Town of Hilton Head Island
Design Review Board Meeting
Tuesday, May 25, 2021 – 1:15 p.m.
AGENDA

i. McDonald's Renovation at 2 Plaza Drive, DRB-001061-2021

DESIGN TEAM/DRB COMMENT SHEET

SHEET TITLE:
SITE PLAN

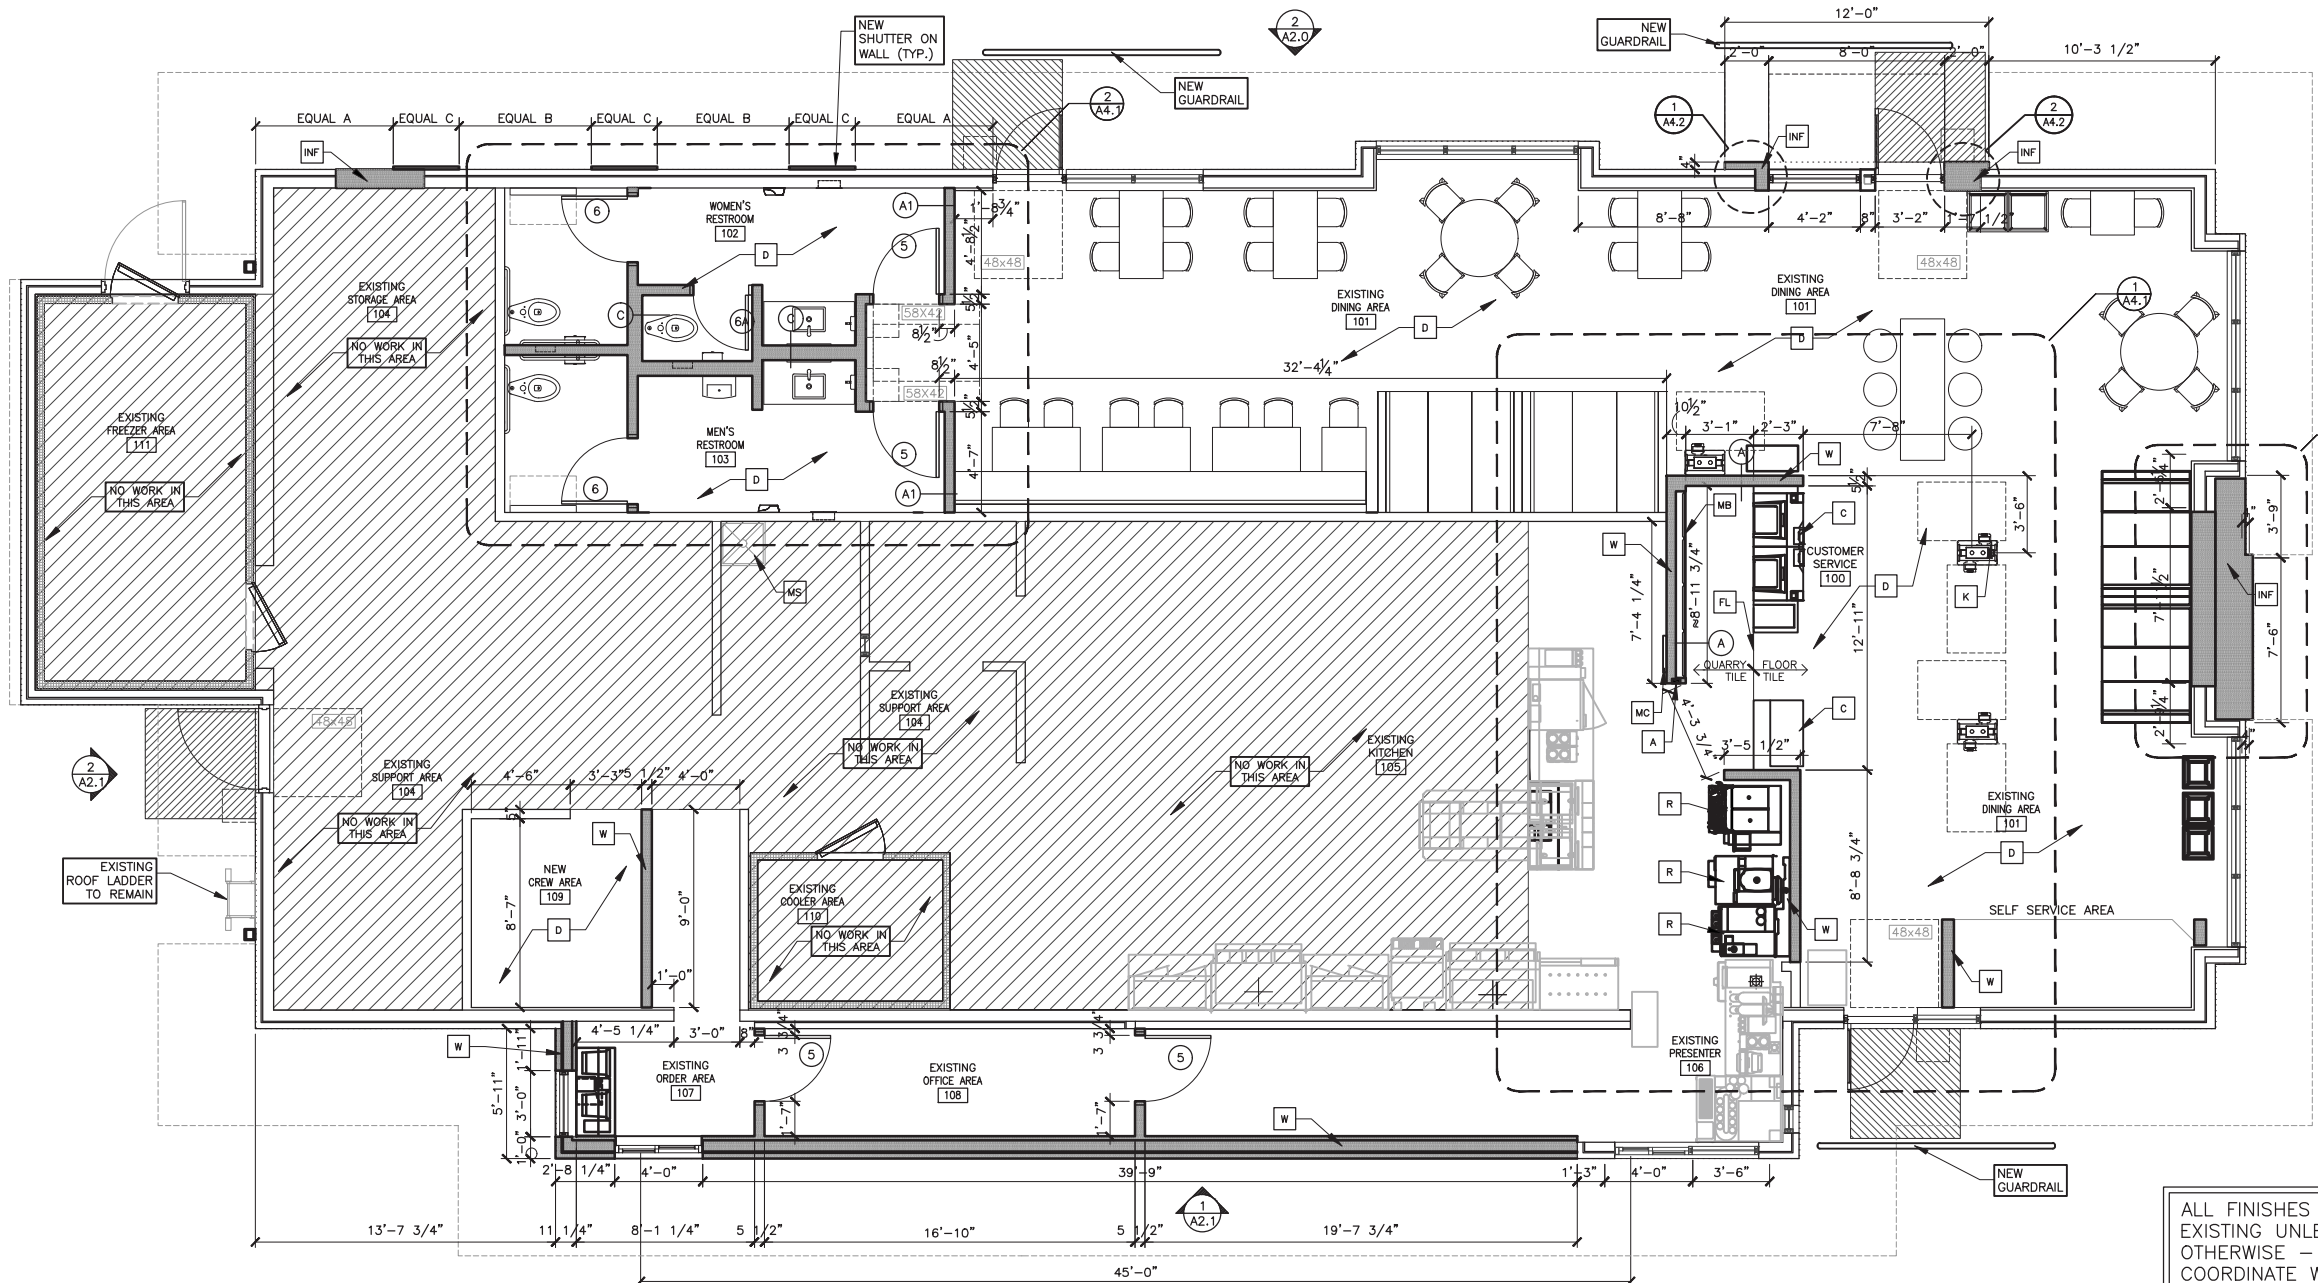
1. Provide a dimensioned Site Plan.
2. Provide physical color samples for the awning structure.
3. Revise the landscape plan to add trees. (Staff received revised landscape plan May 7).

1 FRONT ELEVATION
A2.0 1/4" = 1'-0"

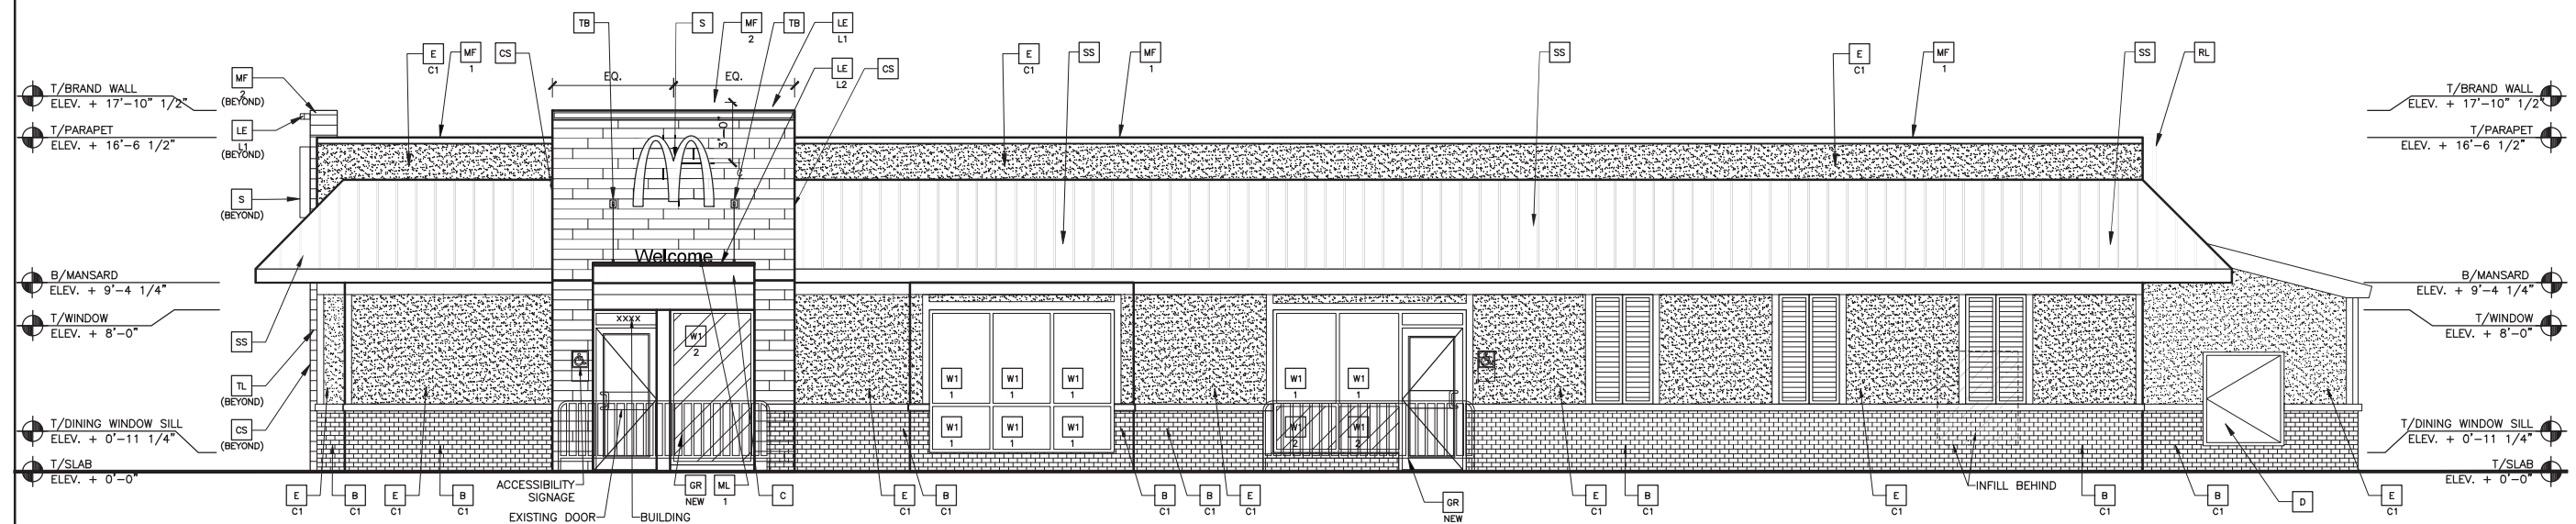
1. This renovation requires a DPR
2. A separate sign permit is required for the signage. It appears the “McDonald’s” on the front elevation may be too large for the architectural feature.
3. Per the Land Management Ordinance, light cannot trespass beyond the property line. See LMO Sec 16-5-108 Site Lighting Standards C.3.
4. The Plant Schedule appears not to reflect the Planting Plan, please revise.
5. The interior of wall face of the dumpster should be painted. Please specify the color.

39-0098 Hilton Head, SC
Trash Enclosure McDonalds

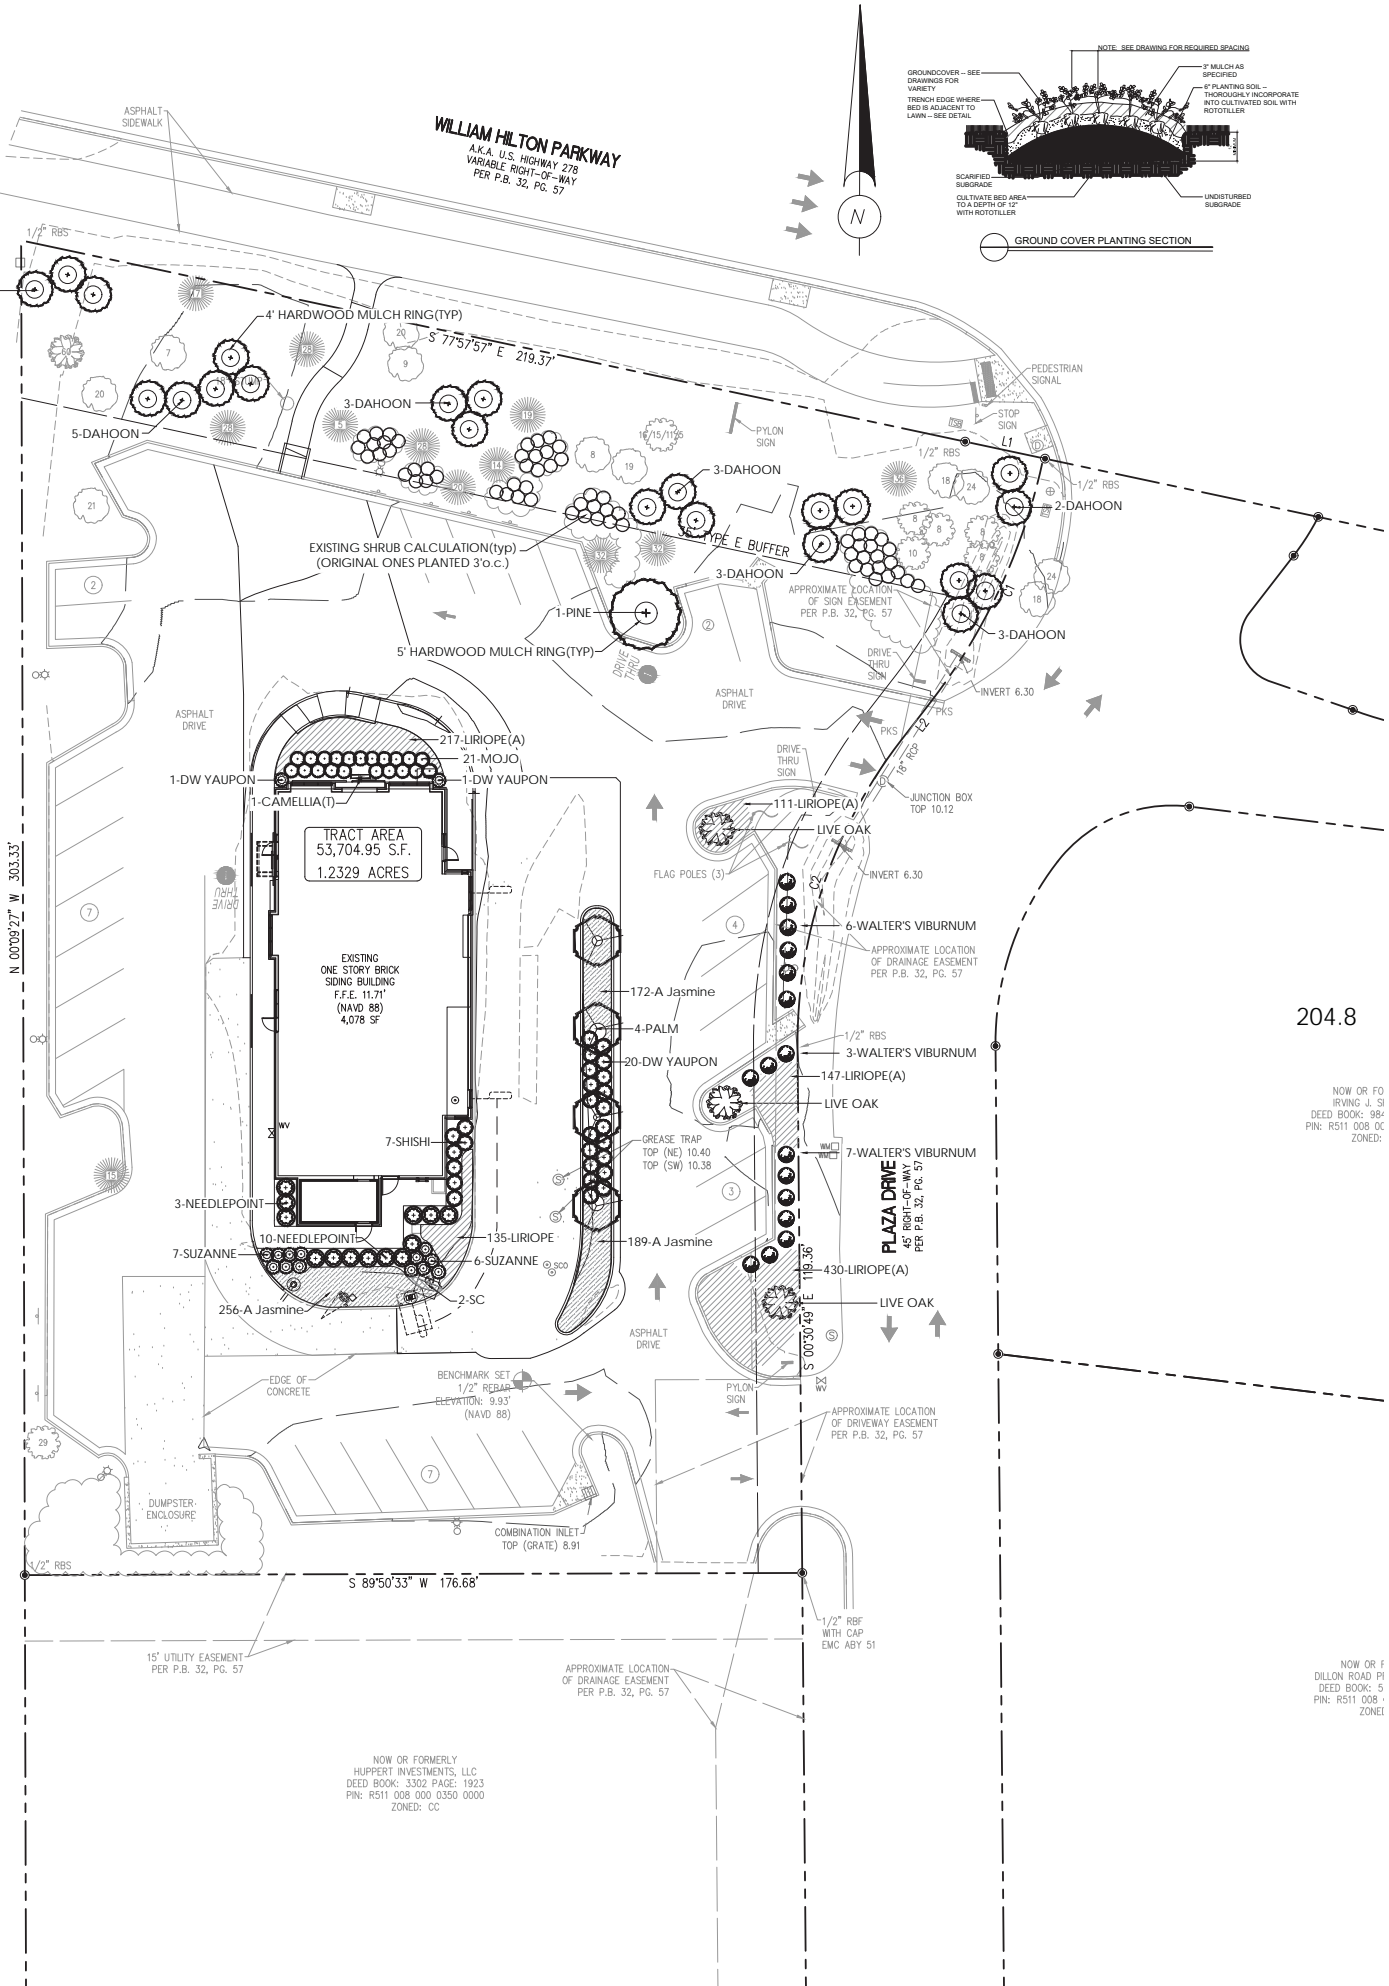
1. Correct the landscape plan and schedule.
2. Revise the lighting plan to eliminate light pollution beyond the property line.
3. Specify a color for the interior wall face of the dumpster enclosure.
